South Gloucestershire Council

Our Reference: P22/01300/O

RE: LAND AT SODBURY ROAD, WICKWAR GL12 8PG

1.0 Description of Proposal and Its Context

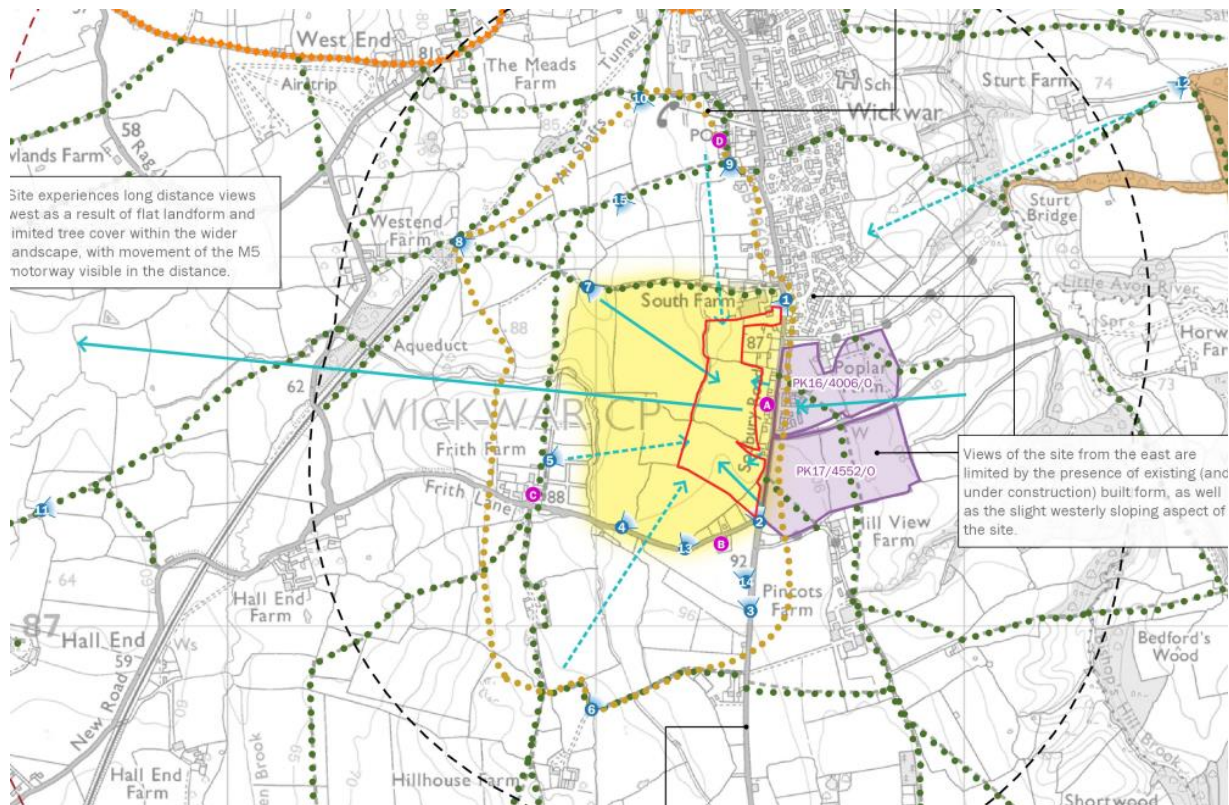
- EDP 3: Findings of EDP's Visual Appraisal - representative assessment viewpoints have not been agreed with SGC, as requested in Screening Opinion feedback. Potential visual effects also need to be assessed from the following viewpoints:

- There is a sequence of views between South Farm and VP7 on the footpath/linear receptor lying parallel to the northern site boundary, including viewpoints with more open/worse case views of the proposals than depicted by VP7 and at least one additional, intermediate viewpoint needs to be assessed.

- There are also views between VPs 7 and 8 on same route, and a further intermediate/worse case view needs to be also assessed from here.
 - Footpath LWR/25 within the CA, further west of VP 9, to complete the visual analysis provided by VPs 9 and 10. On the footpath extending between VPs 8 and 9, which follows the southern boundary of the CA, there are views back to the Grade II* listed church in the CA and also clear views across the site to the buildings being constructed on the opposite side of Sodbury Road. There are clear view lines/vistas towards No. 1 Frith Lane/VP 4, the views from which is discussed below. There is no clear view of the site from the Royal Observer Corp Volunteers pill box.

- Frith Lane between VPs 2 and 4, where a field gate affords a clear view towards the site and surrounding part of Wickwar. From VP 4 the proposed POS margin will appear foreshortened in the view. The tower of the Grade II* listed church of The Holy Trinity, within the conservation area, is clearly seen on the skyline to the left (north) of the listed South Farm. Current, proposed layout would not preserve this view line/vista. There is also a clear view of the church tower from opposite No. 1 on Frith Lane, and there may be other noticeable views of the church in the vicinity of VPs 2 and 3 in winter when adjacent skyline trees have lost their leaves.

- B4060 between VPs 2 and 3, where there is a more open view than that from VP 3; the proposed housing within the SE corner of the site/frontage will be visible and will effectively 'combine' with the new housing on the opposite, east side of Sodbury Road to create an 'enclosed, built corridor' approach into the village.

- Consider that there will be some key views of the proposals from the footpath route crossing higher land near VP 5/paddocks, in which the new housing will be quite noticeable/prominent rather than just glimpsed as annotated on the plan; this needs further review in the LVA.

- The proposals will be seen in views from the listed Frith Farmhouse.
 - Consider that the Zone of primary visibility needs to be extended to take account of the above site observations (e.g. pass VP 7 and also to take in VP5).

- Section 2.1 states 3No. additional assessment viewpoints were requested, when in fact the above advice discussed some 6No. additional locations; Table 4.1 identifies new VPs 13-15 are respectively located at the field gate along Frith Lane (between VPs 3 and 4), field gate along B4060 (between VPs 2 and 3), and PROW LWR/25 NW of the site (between VPs 8 and 9), as shown on the plan extract above.
